PEER REVIEW Visual Impact Assessment of CBM Quarry ANALYSIS AND RECOMMENDATIONS

CBM Quarry has submitted an application for an Official Plan and Zoning By-law amendment to the Town of Caledon to permit a mineral extraction operation on a 323-hectare site. A Visual Impact Assessment (VIA) was prepared by Golder and Associates to evaluate the visual impact of the proposed quarry and its influence on the surrounding landscape. As part of the review process, the Town of Caledon requested a peer review to be conducted to critically analyze the methodology and findings in the Golder VIA, the Landscape Plans prepared by MHBC and in the Planning Justification Report. The Peer Review is the subject of the following report.

Figure 4: Additional Viewpoints

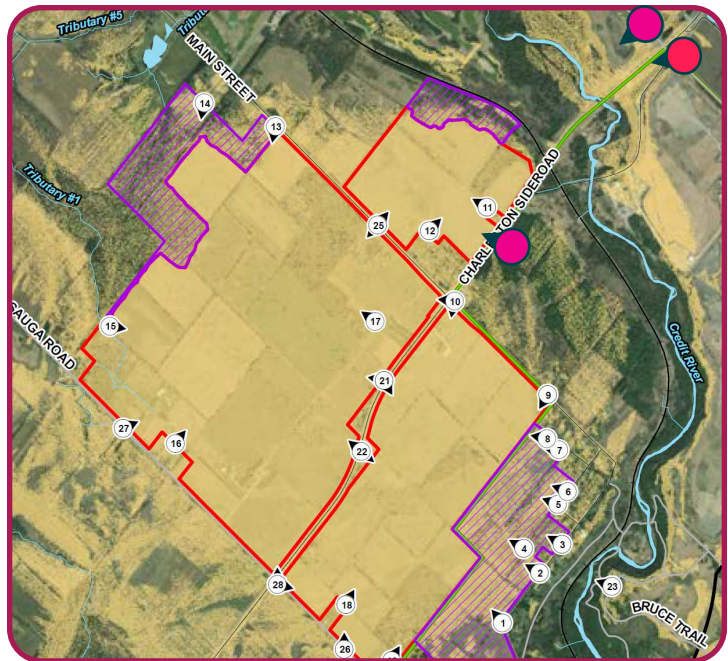
Two important sites that provide panoramic views of the applicant's landholdings are located northeast of the Credit River as shown in Figure 4. In the east locations, public parking lots are located on both sides of Charleston Side Road and provide direct panoramic views of the North Extraction Area and potentially the Main and South Extraction Areas. These viewpoints should be added to the Golder VIA Report.

Another viewpoint at the south boundary of the North Extraction Area is significant and should be added as it includes views from the roadway and the backs of the properties at Charleston Side Road and Main Street.

7. **New Viewpoints** The Golder VIA Report should include the additional viewpoints shown on page 15.
8. **Consistency in Landscape Plans** Drawings included in the Golder VIA Assessment and the MHBC Landscape Plans and planting notes/specifications should be updated to include all proposed landscape mitigation and remove conflicting information.

Figure 6: Quarry Entrance on MHBC Operational Plan A0002

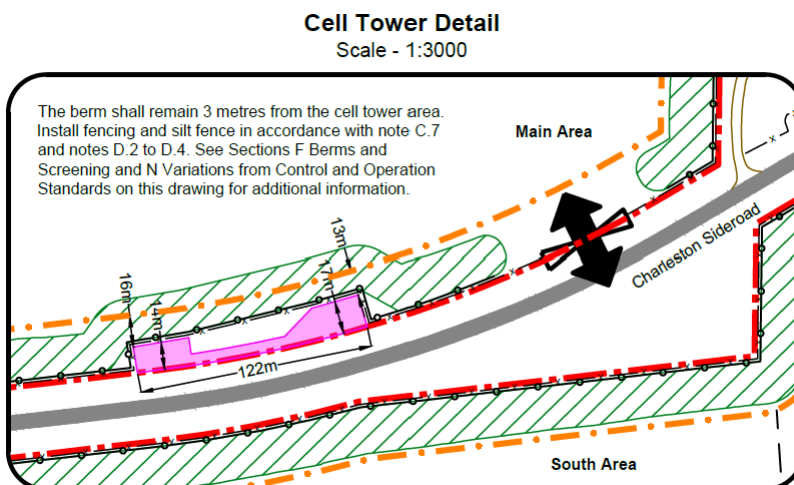
The proposed quarry entrance treatment as shown in MHBC Landscape Drawing A003 and at Viewpoint 22A in the Golder VIA Report is misleading and will result in unsightly views into the quarry. Assuming the quarry entrance road is constructed at an 8 - 10% maximum grade, the length of road needed to achieve the berm height of 5-7m is 40 - 56m in length; however, the berms (with a 3:1 slope) will achieve this height in half the distance, resulting in many views into the quarry operations. The only way to have a perpendicular entrance road that angles upward to block views into the quarry is to have the entry berms extend farther back into the quarry, however, this treatment is not shown in Figure 6 below. A grading plan in plan view and 3D plans using Sketchup, Civil 3D, or the like, should clearly indicate that views into the quarry at the entrance are completely blocked. Examples of alternative layouts, using a combination of curved quarry entry roads and adequately sized and shaped berms that would be acceptable are shown in Appendix B.

A detailed grading plan for the quarry entrance road, berms and landscape mitigation design for all quarry entrances needs to be provided to enable a proper assessment of the visual impact.

- 14. Quarry Entrance** Additional details to assess the visual quality of all quarry entrances should include a grading plan and sections showing the grade of the berms and quarry entrance road, location of plantings, fencing or other visual screens, and 3D renderings to indicate that views into the quarry extraction area are blocked from all viewing angles from the public roadway.

Figure 7: Boundary of Coulterville Special Study Area

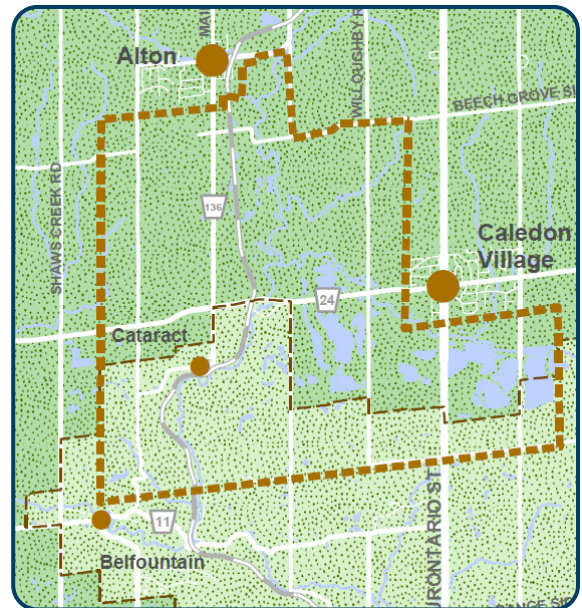
A more insightful plan for this intersection that anticipates potential tourism growth is needed. This type of plan requires the Town of Caledon to develop a vision for the Coulterville and for the applicant to then develop appropriate mitigation measures for the quarry operations.

- That the intersection be demarcated as an interim study area that is not bound to the extent of quarry extraction and landscape rehabilitation shown to the left
- That the applicant not be permitted to extend the limit of extraction into this area until the plans for the Coulterville Study Area have been finalized
- That this intersection not be designated as a woodland planting area until the Coulterville Study Area plans are finalized

Figure 9: Operational Landscape Mitigation Shown on A002 MHBC Drawing 2 of 4

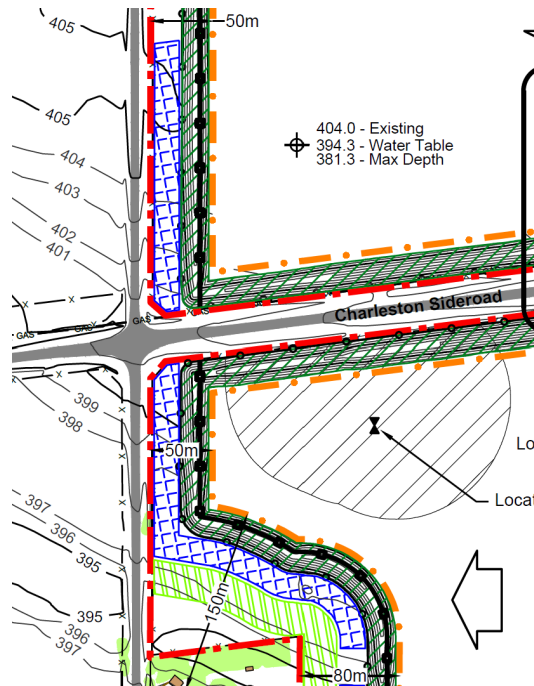
This intersection will act as both a gateway and an exit for viewers who will experience the CBM Quarry site. The operational landscape treatment (Year 0 - 50) shown in Figure 9 is of low quality as it consists of two steeply sloping seeded berms that form an unnatural right-angle shape on both corners. The rehabilitated landscape (Year 50+) is only slightly better in the southeast corner as it has a more natural shape with a proposed island which creates a point of interest; however, the northern corner is quite harsh.

- 16. Intersection of Mississauga Road and Charleston Side Road** An improved landscape treatment than shown in the Operational and Final Rehabilitation Plans should be created at this visually prominent intersection to enhance visual quality.

Figure 10: Proposed Rehabilitated Landscape Shown on A004 MHBC Drawing 4 of 4

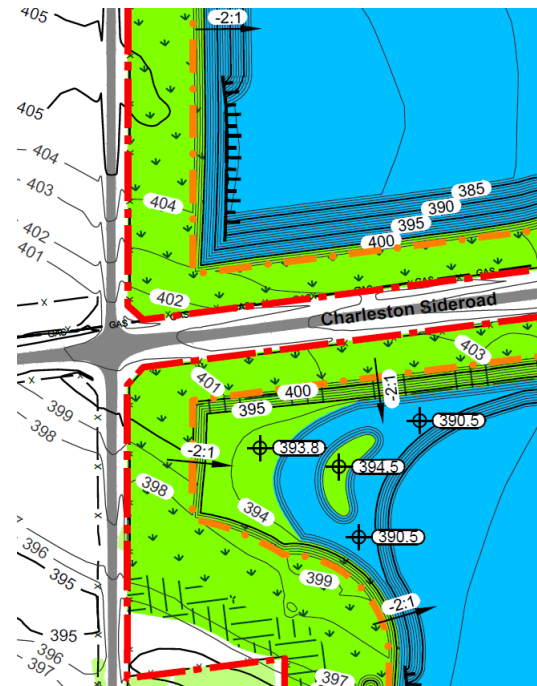
A landscape treatment similar to the natural shape shown in the southeast corner of Figure 10 should also be shown on the northeast corner, during the operational stage and the rehabilitated stage. Changes to the contouring during the operational stage will likely require a change to the limit of extraction so that a better corner treatment can be created.

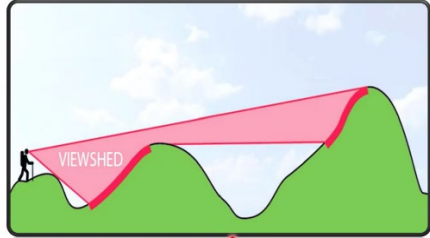
6 c)	VIA Cross Sections		
	Cross sections are shown with an exaggerated vertical scale and the resulting sight lines (shown in red) are, therefore, not precise. Horizontal and vertical scales in cross sections must match to accurately indicate the true line-of-sight and visual shadow areas. Additionally, no key plan is provided showing where cross section lines are located. Lastly, the view 2 cross section shows visual planting but there is none proposed in that area. Cross sections of	An exaggerated vertical scale in the cross sections was used to make the landscape features and shadow areas more visible in the cross-section figures. An exaggerated vertical scale does not affect the precision of cross sections. The key plan of site cross-sections is included in Attachment D . Updated cross-sections for viewpoints 2, 5, 9, 10a and 10b are included in Attachment E .	We agree with the NEC that the vertical and horizontal scales for a visual impact assessment must be equal, and the cross-sections should be redone. The key plan shows all cross-sections on the same map and is not helpful to the analysis. Instead, a plan view of each cross-section that shows the extent of the viewshed should be provided for each viewpoint. This includes the updated cross-sections provided by the applicant. Other amendments to the cross-sections needed are as follows: - indicate whether trees are existing or planted, the date planted, and whether they are coniferous or deciduous
